ENERGY STAR 2011 Qualified New Homes Comments

This is a compilation of all comments received by EPA during the second ENERGY STAR Qualified New Homes comment period ending December 16, 2009.

Example: Electric and Gas Water Heaters Site vs. Source Energy Comparison

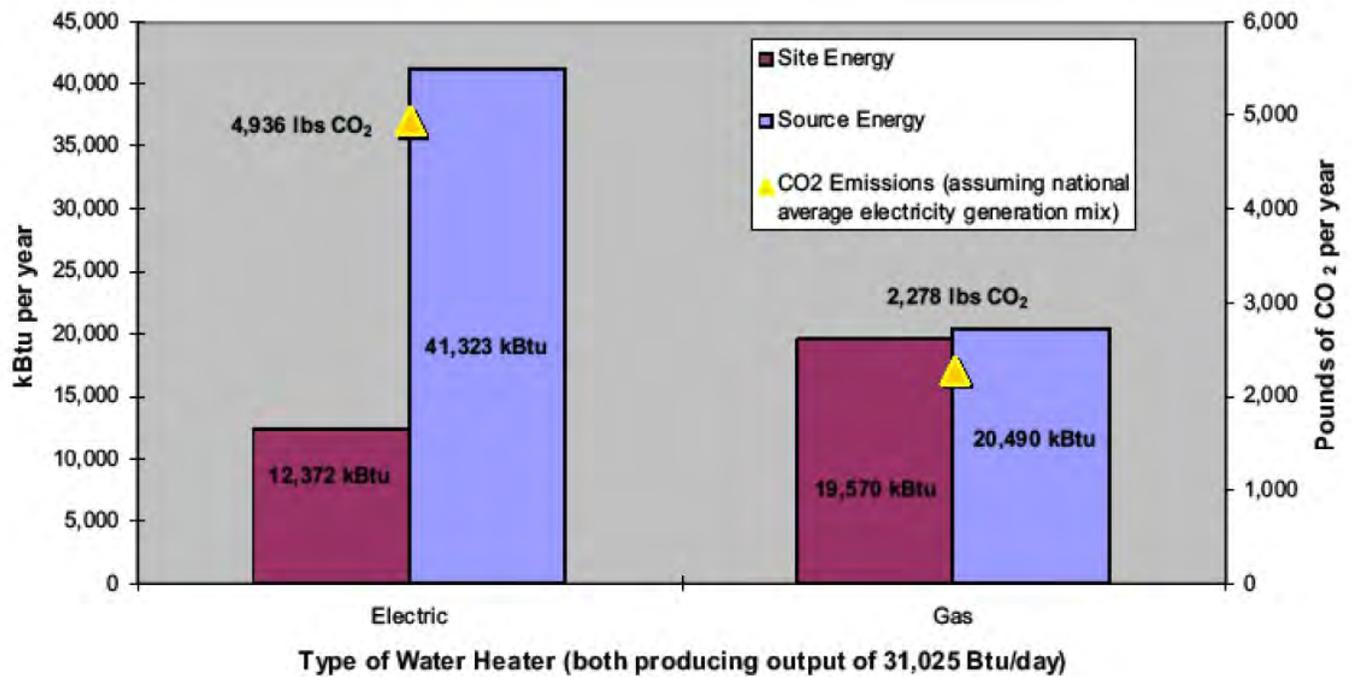
EPA applies inconsistent use of ENERGY STAR appliance requirements wherein it accepts the ENERGY STAR appliance furnace efficiency requirements for furnaces in ENERGY STAR HOMES (Comment #14), but rejects similar consistent use of ENERGY STAR water heater requirements (Comment #179), and does so without providing technical support of its contention on "incremental cost" being "too great" to require consistent treatment...

EPA's response to AGA's comment on using ENERGY STAR appliance criteria for water heating "incremental costs" as being "too high" (Comment #179, "EPA's Response") is vague, unsubstantiated, and is unresponsive to the use of substitute storage water heating technologies including natural gas storage water heaters meeting the ENERGY STAR criteria for houses on natural gas mains and similar propane gas storage water heaters for houses off natural gas mains. Clearly, these substitutes are not prohibitively costly on an "incremental cost" basis and produce substantial CO₂e reduction opportunities fitting with EPA's "primary goal ... to maximize carbon reductions" (Comment #73, "EPA's Response") as was demonstrated in AGA's comments on the previous draft (slide attached).
